Project Modifications Document

Cochrane Solar Project

JUNE 2019

SAVANTA FILE: 8137

Figure 1
Project Location

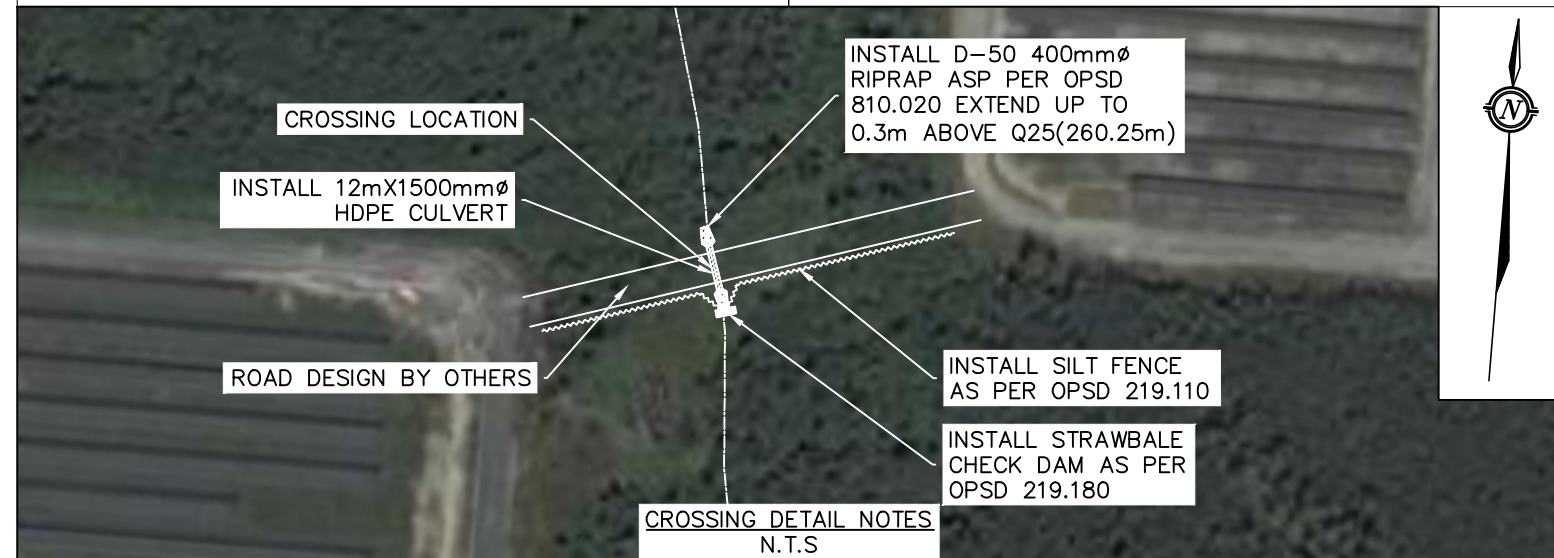
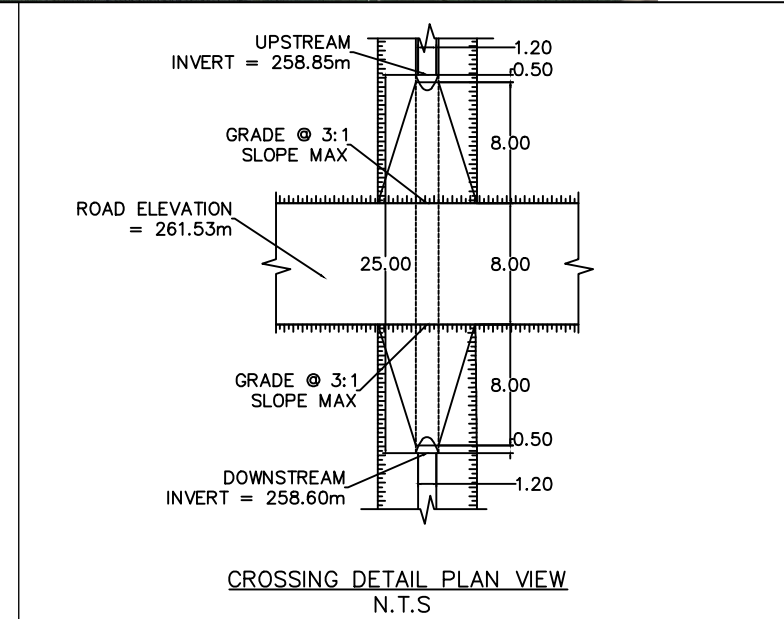
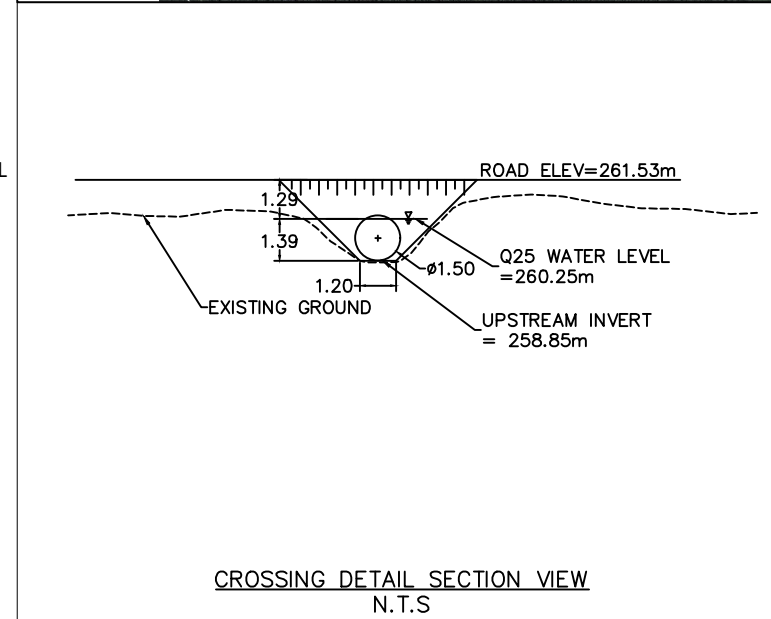
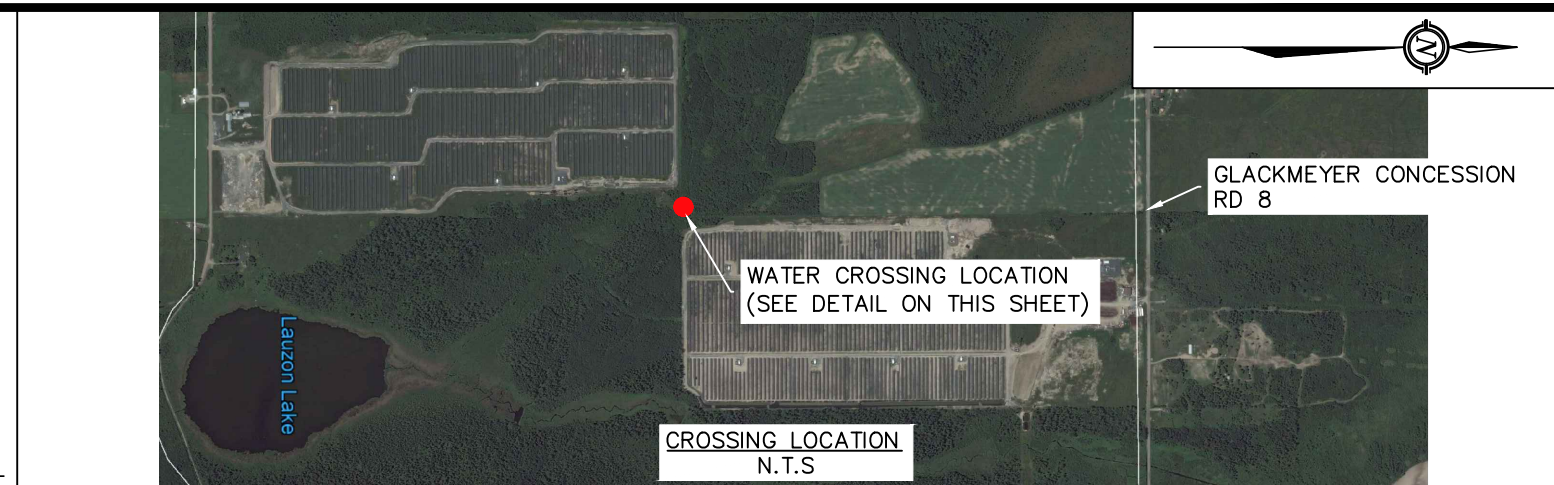
Northland Power has also identified a need to construct a storage building on the Martin's Meadows portion of the facility. The purpose of the storage building is to house snow removal equipment. The proposed building will be approximately 9.1 m wide by 18.2 m long and 4.9 m high for a total overall footprint of approximately 165 m². It will be located at the north end of the facility, in an existing disturbed area in proximity to the existing operations and maintenance building (**Figure 1, Appendix A**).

The proposed access road will be a 112-m long, granular surface access road between the Empire and Martin's Meadows project areas (**Figure 1, Appendix A**). A 25-m long, 1500 mm diameter HDPE (smooth interior surface) pipe will be required to cross an unnamed intermittently flowing tributary of Munroe Creek. The design drawing for the water crossing structure is provided in **Appendix B**.

The proposed storage building will be located at the north end of the Martin's Meadows area of the facility (**Figure 1, Appendix A**). The proposed building will be approximately 9.1 m wide by 18.2 m long and 4.9 m high for a total overall footprint of approximately 165 m². The one-floor building will be constructed of a steel structure and siding with a concrete slab floor. A manufacturer's brochure depicting the general design of the building is provided in **Appendix E**.
